UNITED STATES PATENT AND TRADEMARK OFFICE

APPLICATION NO.	FILING DATE	FIRST NAMED INVENTOR	ATTORNEY DOCKET NO.	CONFIRMATION NO.
10/801,524	03/12/2004	Gary Wayne Hogue	4705-2	3181

Office Action Summary

DETAILED ACTION

FIG. 1

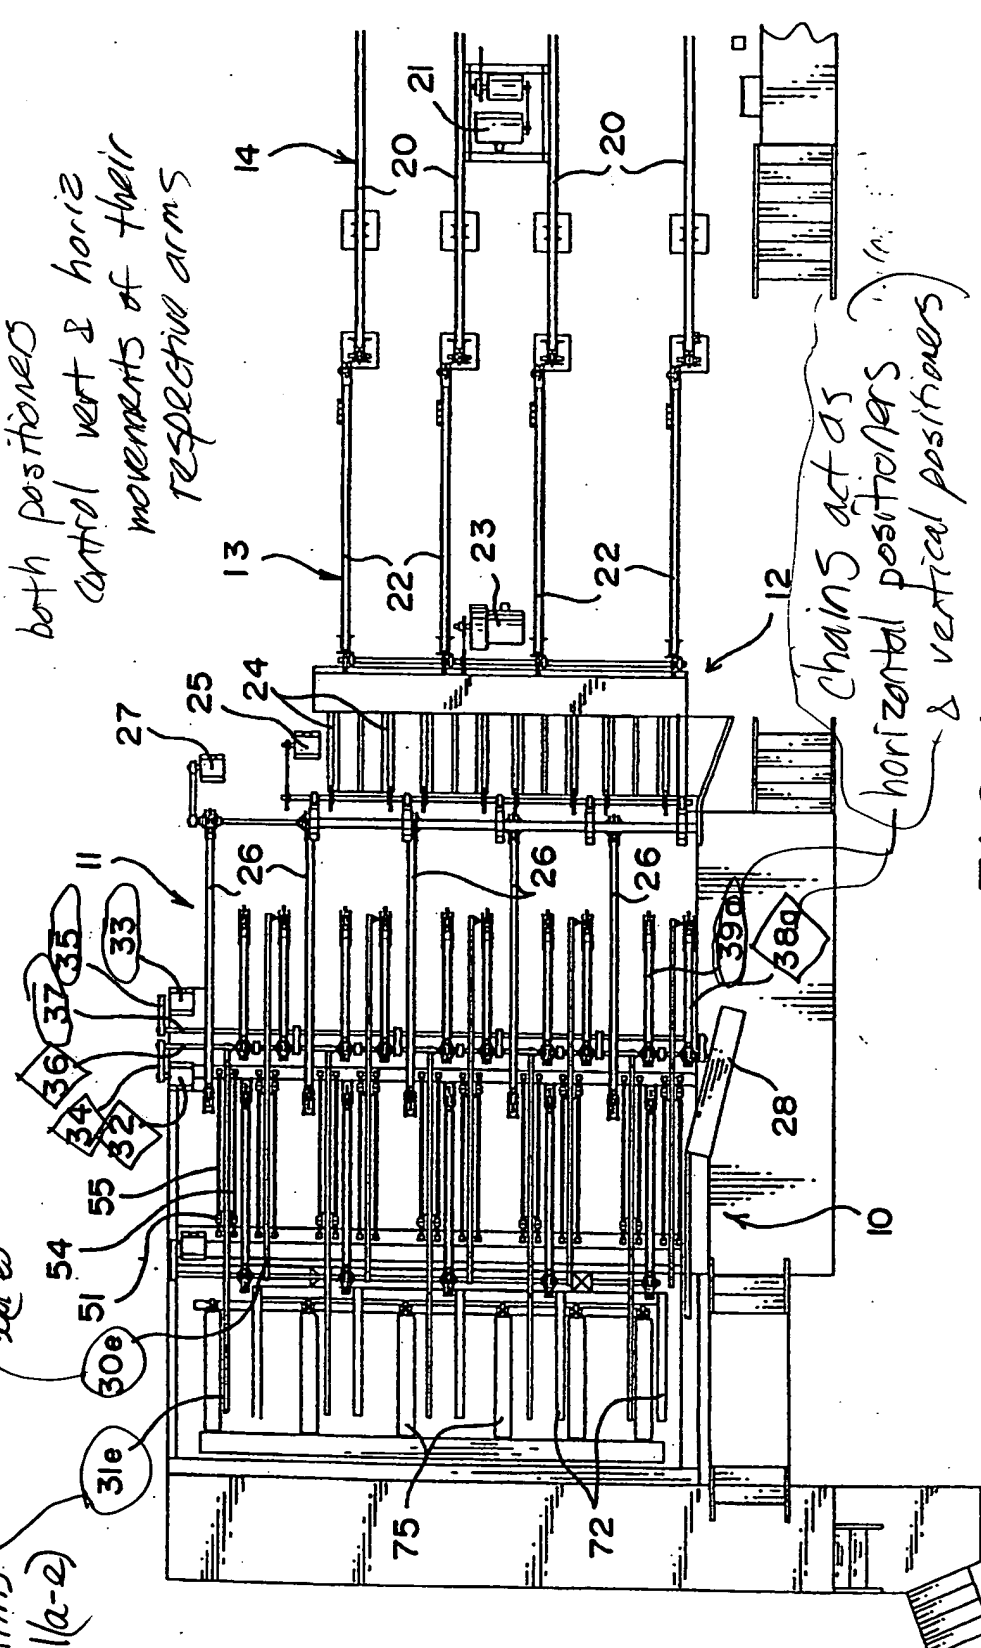
See the attached marked up drawing figure 1 of Vande Linde depicting the claimed features.

1st elect.-controlled positioner = 32, 34, 36, 38
2nd elect.-controlled positioner = 33, 35, 37, 39

1st Set Stacking Arms 30(a-e)
2nd Set Stacking Arms 31(a-e)

both positioners control vert & horiz movements of their respective arms

controls speed, but does not change speeds
electronic control system = see spec COL 5, line 45
and COL 7, line 21

RE claims 7-8
1st positioners are engaged & disengaged by
2nd positioners

(claim 2) provides hard-coupled system to generate horiz. movement of stacking arms as claimed
